THE PARLIAMENT OF THE COMMONWEALTH OF  
AUSTRALIA

JOINT COMMITTEE ON THE  
AUSTRALIAN CAPITAL TERRITORY

REPORT ON  
PROPOSALS FOR VARIATIONS OF  
THE PLAY OF LAY-OUT OF  
THE CITY OF CANBERRA AND ITS  
ENVIRONS

(SIXTY-FIFTH SERIES)

MAP P4

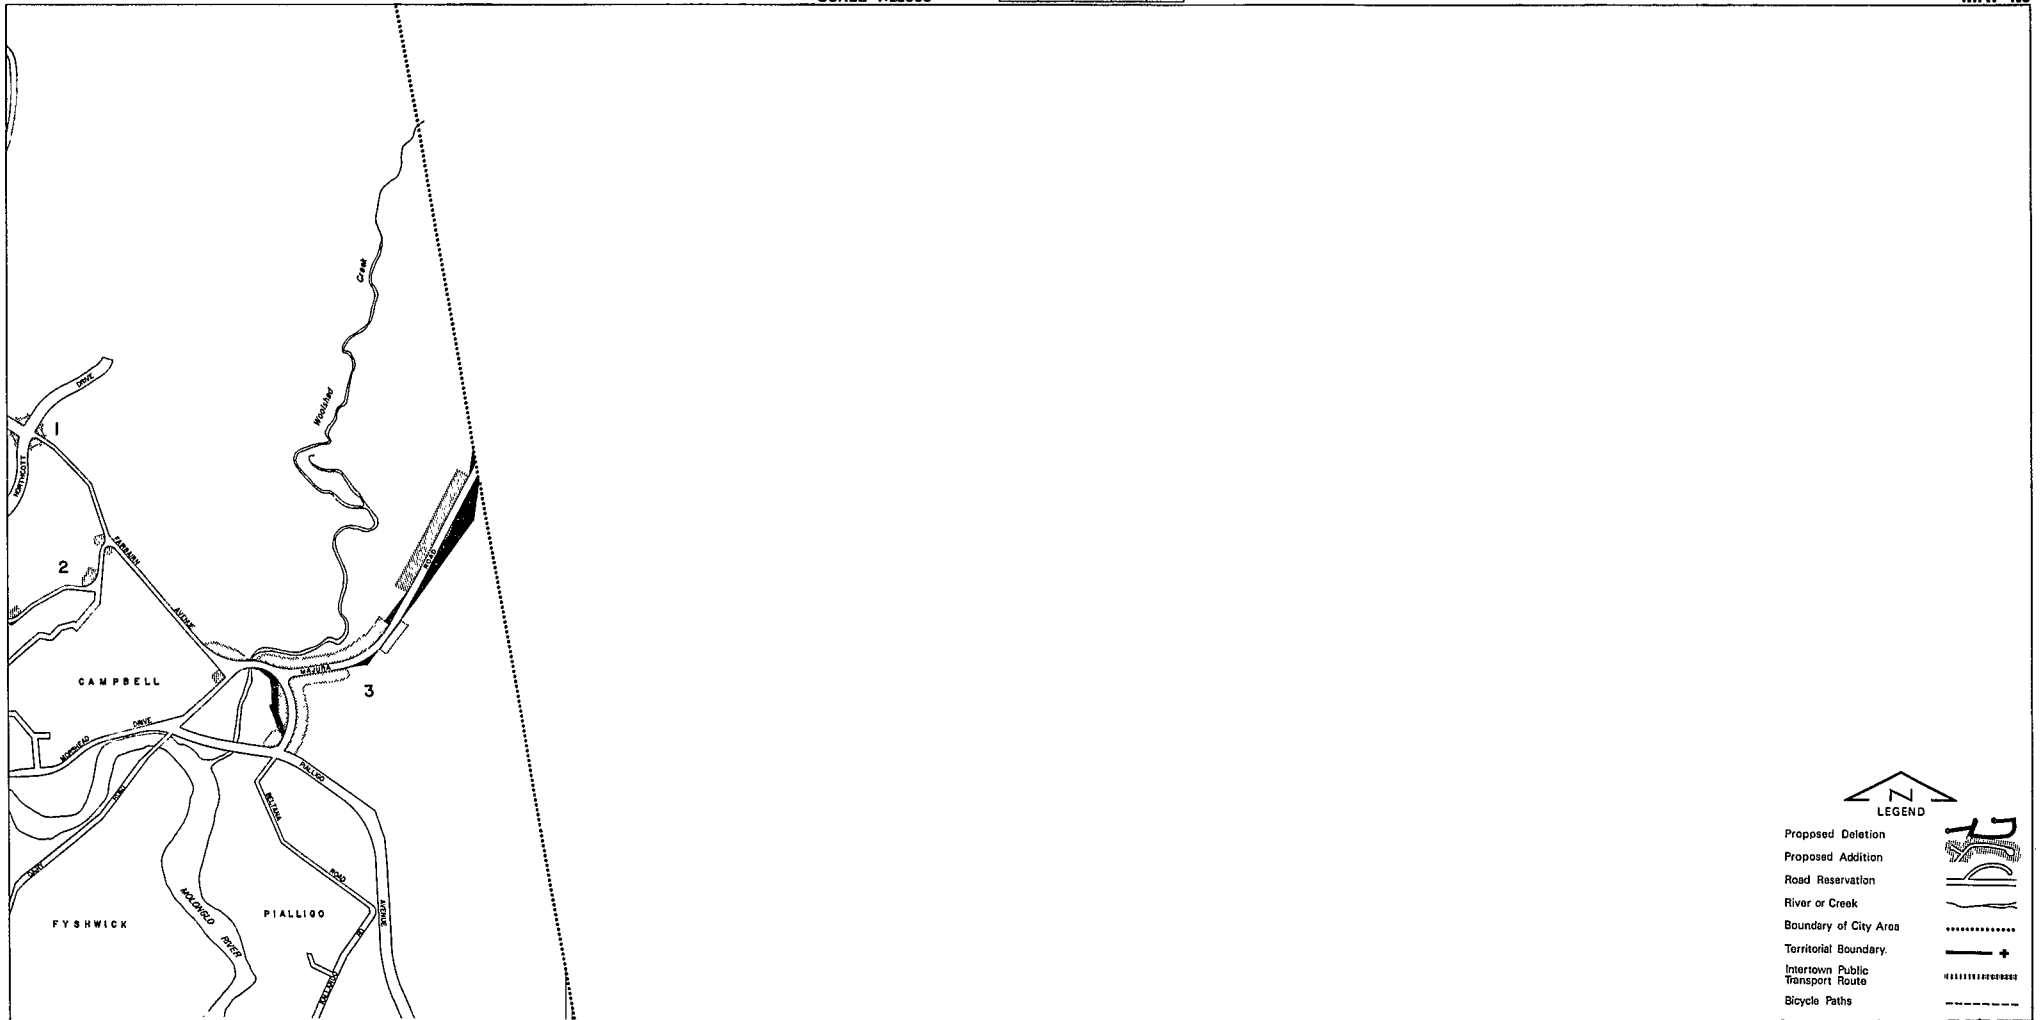
9. These variations are intended to service 210 detached housing blocks and 13 cottage blocks in the two sections of Latham. The land is adjacent to both the proposed rapid transport route and Ginninderra Creek.

10. The proposed developments have been objected to on transportation, environmental, and recreational grounds by the Society for Social Responsibility in Science, Action for Public Transport, and the Ginninderra Community Council.

11. The basis of the transportation objections is that higher density housing is needed adjacent to any rapid transport route in order to run the transport system economically. It is also claimed that further areas of higher density housing are needed in North West Belconnen to balance the proportion of standard detached housing. The area is close to the Charnwood shopping centre and is considered to be a suitable area for higher density housing.

12. The Ginninderra Community Council's <sup>OBJECTION</sup> letter <sup>OBJECTION</sup> recommends that "If sub-division of this land for higher density housing is not opportune at present, the area should remain vacant. The principle of optimum land use should not be foreclosed by any premature sub-division".

13. The objections to the proposed development on environmental and recreational grounds are based on the proximity of the proposed development to Ginninderra

Creek. Housing will come within 100 metres of the Creek in Sections 105-115, which the Council considers leaves inadequate area for a natural bushland reserve. It is said that the housing development will occupy land needed for recreation and affect the visual amenity of the area.

14. On the question of access to the future rapid transport system, an officer from N.C.D.C. informed the Committee that, as yet, no transit stops have been determined. Although the sections under consideration might be adjacent to the route, they may not be adjacent to any future transport stop. An officer reaffirmed the Commission's view that there were adequate medium density sites preserved at such places as the town centre and in particular, in the Florey area\*.

15. In view of the fact that the Committee has already approved developments in this area in the 63rd series of variations, which are closer to the Ginninderra Creek than these proposed developments, the Committee will not withhold approval for variations two and three of the 65th series.

16. However, the Committee is concerned about the future availability of Ginninderra Creek for recreational use and it is seeking from N.C.D.C. detailed information on the future use of the Creek area during briefings on the 66th series. It is desired that the briefing will include the land use and recreational proposals for the whole area, clearly showing <sup>the</sup> full extent and limits of residential development near the Creek. In view of this request, the Committee ~~suggests~~ <sup>requests</sup> that Blocks 102, 103 and 104 should not be further developed until the Committee has received the detailed briefing ~~as requested.~~

17. The Committee also considers that, in preparing any proposals for the development and use of the Creek area, there should be full consultation between N.C.D.C. and the community, including such groups as the Ginninderra Community Council and Society for Social Responsibility in Science.
